Re: Source Materials License SUA-1534
Docket No. 40-8943
Mine Unit 1 Restoration; Response to Request For Additional Information

**Crow Butte Resources, Inc.
Response to U.S. Nuclear Regulatory Commission
Request For Additional Information**

Mine Unit 1 Groundwater Restoration Completion

Crow Butte Uranium Project

**Figure 1
Reduction of Uranium per Pore Volume Treated**

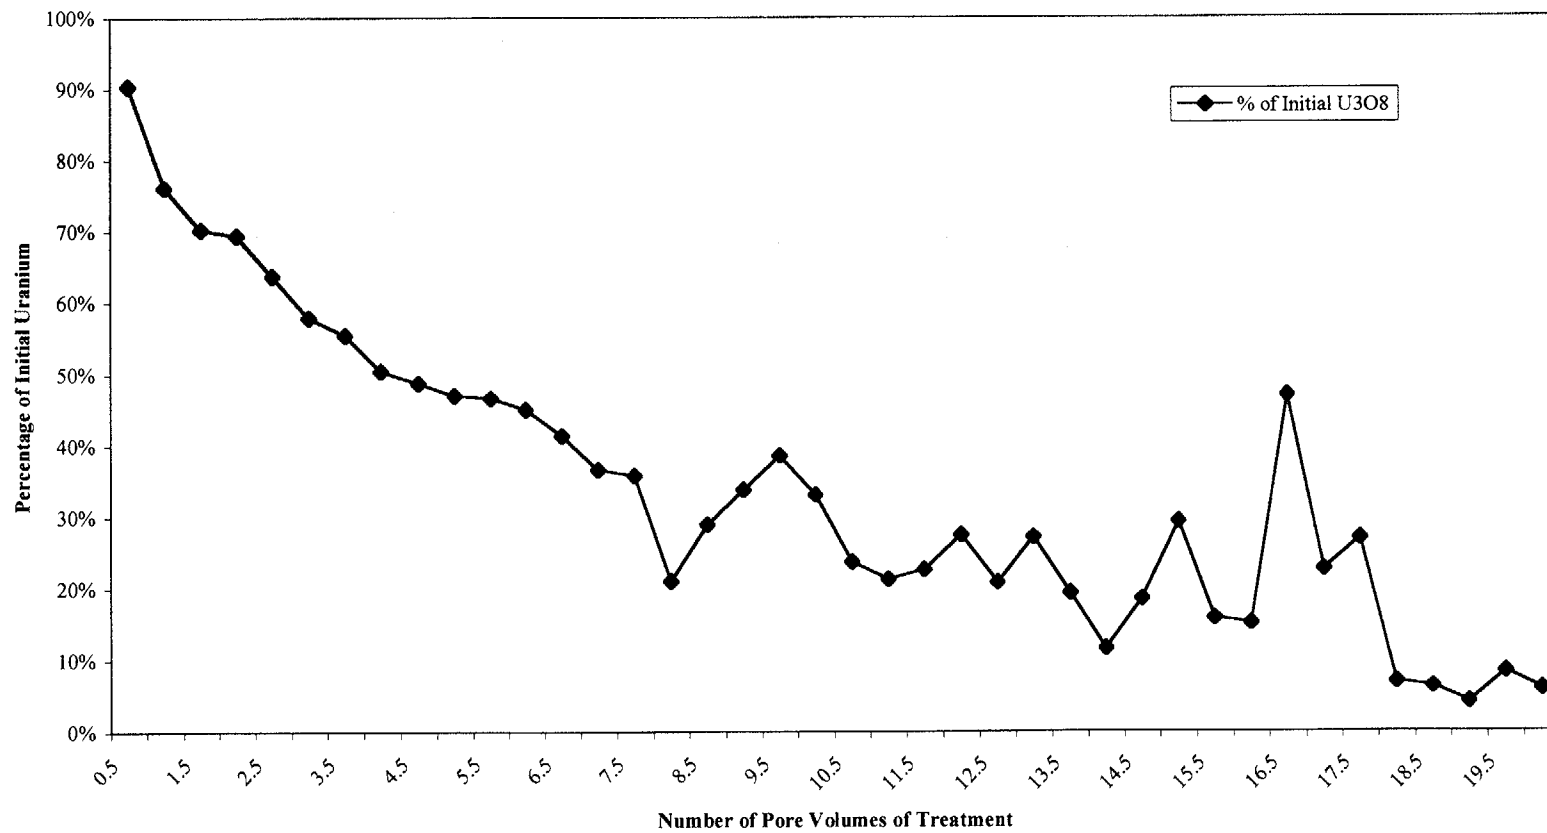
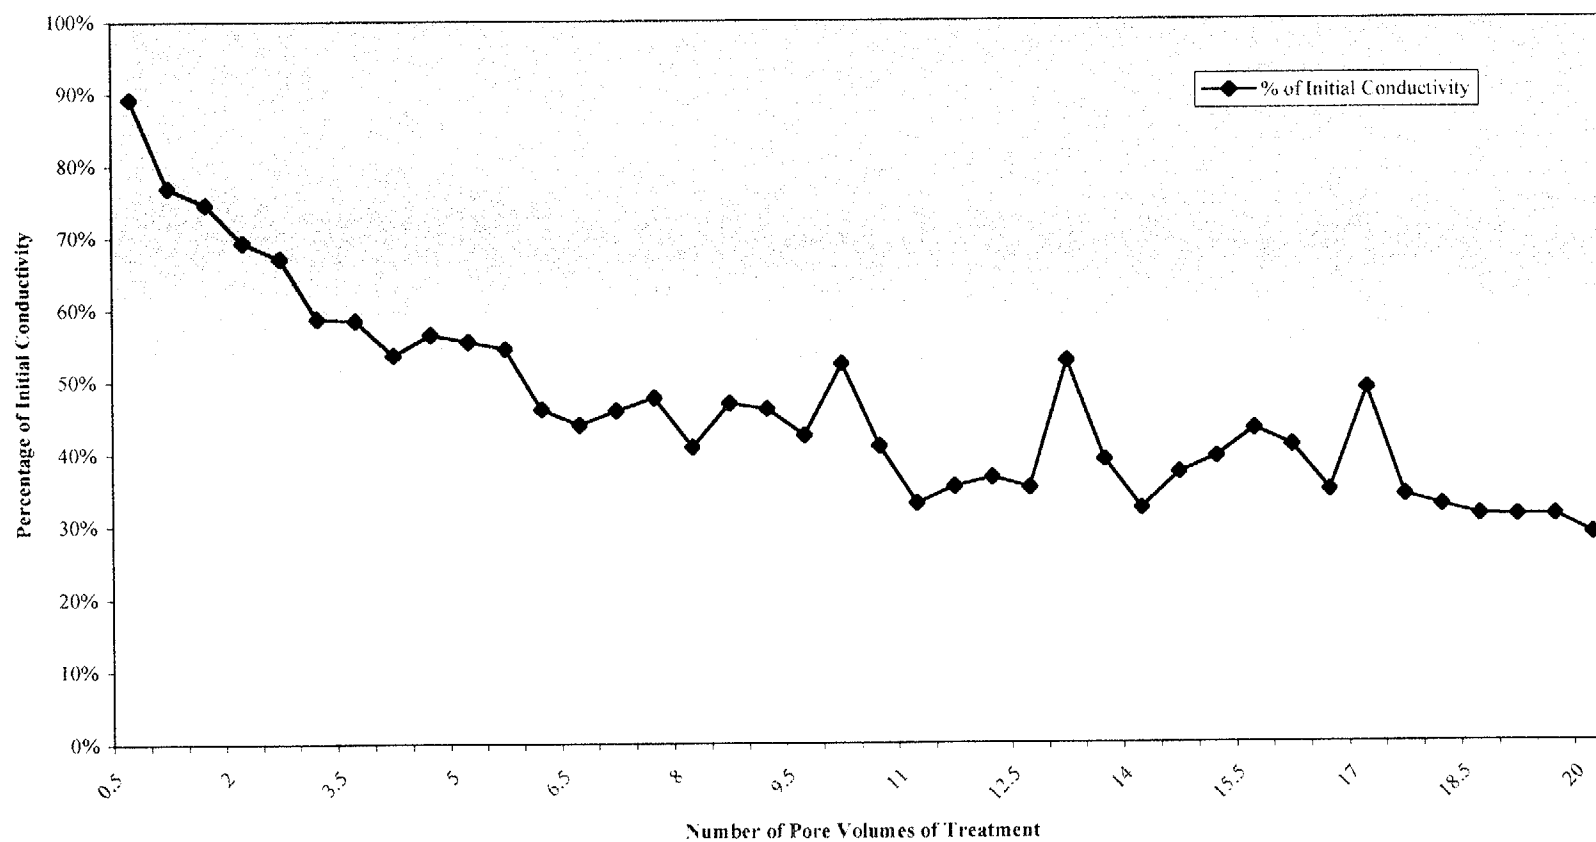
The licensee must provide a written description of the attempts and effort it put forward to attain the primary restoration goals for Unit 1 contained in the approved license application. The description should include a listing of those parameters that meet the primary restoration goal and those that are above the primary restoration goal, as well as those at or below the secondary restoration goal. The description should also include the technical or economic reasons why it was not possible to achieve the primary restoration goals.

Recognizing that the treatment processes employed are not 100 percent effective, a point will be reached during treatment when additional efforts will result in minimal improvement in the water quality. Restoration efforts in Mine Unit 1 proceeded beyond the point where significant improvement was possible with continuing treatment. To illustrate this, Figures 1 and 2 contain summary data for the restoration patterns that compares the percentage of reduction of uranium and conductivity from the initial, post-mining concentration with the total number of pore volumes processed during groundwater treatment. From these graphs, it is apparent that further processing quickly loses effectiveness after the initial pore volumes.

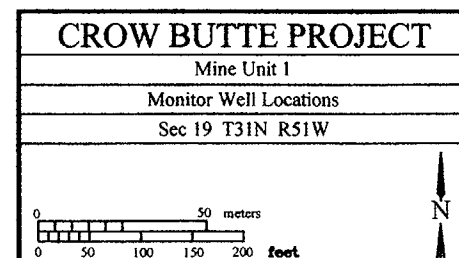
The licensee must submit additional monitoring data to show that all measured constituents have reached the restoration goals in License Condition 10.3 and that the restored concentrations are stable, as demonstrated by no strongly increasing concentration trends through time. These data should be presented in time versus concentration graphs of each constituent, with the restoration standard indicated on the graph. Tables of numerical values used to compile the graphs, and laboratory measurements should also be included. These data should include the time period just prior to and during the stabilization period, and measurements taken since the end of the 6-month stabilization period. The licensee must also submit iso-concentration maps of uranium, radium-226, total carbonate, and total dissolved solids in the Unit 1 restoration wells and perimeter monitor wells, once the restoration has stabilized, to illustrate well field water-quality conditions at the end of stabilization.

To provide additional data supporting the assertion that Mine Unit 1 is relatively stable, CBR has summarized monitoring data for three Mine Unit 1 baseline restoration wells that have been sampled routinely since the stabilization period. These wells were designated as perimeter monitor wells in December 1999 following the approval of the Mine Unit 1 restoration by the NDEQ. The three wells (PR-8, PR-15 and IJ-13) were selected to serve as perimeter monitor wells for Mine Units 2 and 3 and are evenly distributed in Mine Unit 1. Figure 3 shows the location of these three wells within Mine Unit 1.

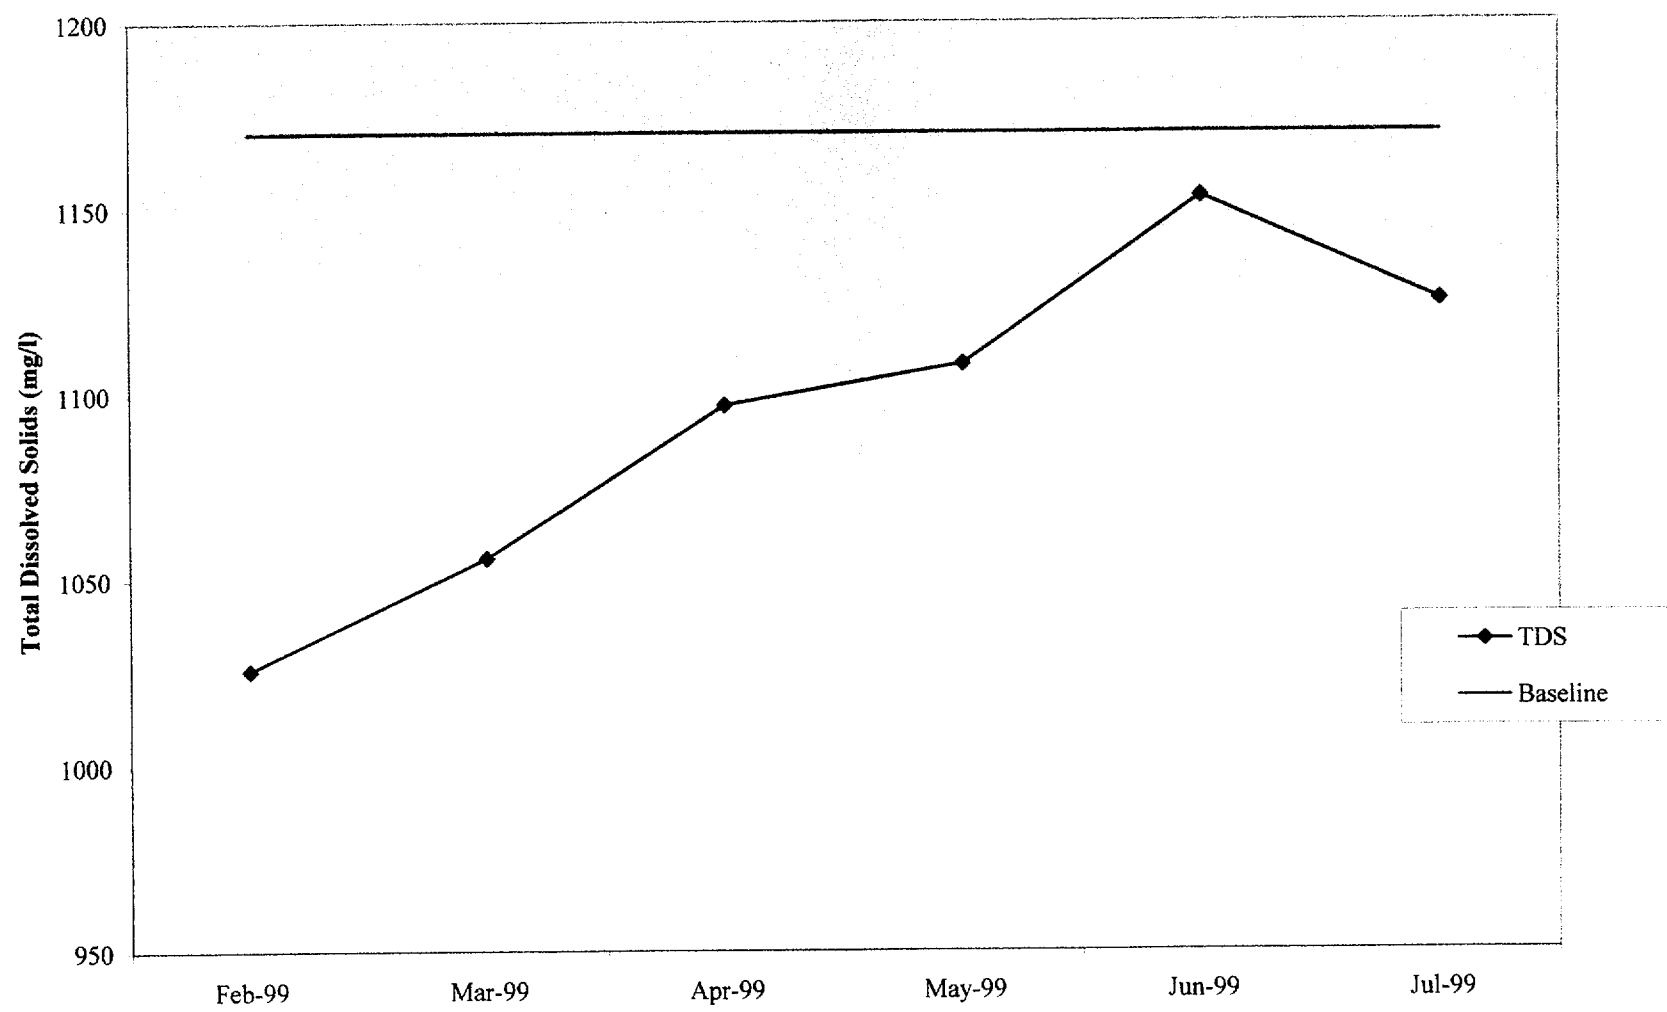
Describe how the well field contamination flares, between the wellfield and the perimeter monitoring wells on the north and south sides of Unit 1, have been restored. Provide any monitoring data, analyses, or calculations that show restoration has occurred in these areas.

In Section 3.2 of the Mine Unit 1 Restoration Report, CBR describes the limited use of groundwater sweep during restoration due to the configuration of the surrounding mine units. In place of ground water sweep, CBR used a series of ground water transfers to replace high TDS mining solutions with baseline TDS groundwater within Mine Unit 1. The transfers produced similar results, as would an extended groundwater sweep program, with the exception of recovering mining solutions that had flared beyond the mine unit boundaries. Although some mining solution was recovered during the groundwater sweep phase of restoration, the solution was primarily recovered during reverse osmosis treatment of the edge patterns adjacent to these areas. This fact is demonstrated when comparing the number of pore volumes of reverse osmosis treatment needed to return the edge patterns to baseline conductivity, as compared to the interior patterns. An average of 8.4 pore volumes of reverse osmosis treatment was required to return the groundwater in the north and south edge patterns of Mine Unit 1 to baseline conductivity, versus 6.0 pore volumes for the rest of the Mine Unit 1 patterns. This would indicate that flared mining solutions were drawn into these edge patterns during reverse osmosis treatment. Since baseline groundwater conductivity was achieved in these edge patterns during reverse osmosis treatment, it would mean that the groundwater outside of these patterns was also returned to baseline conductivity, indicating that the flared mining solution was recovered from the areas north and south of Mine Unit 1 during restoration.
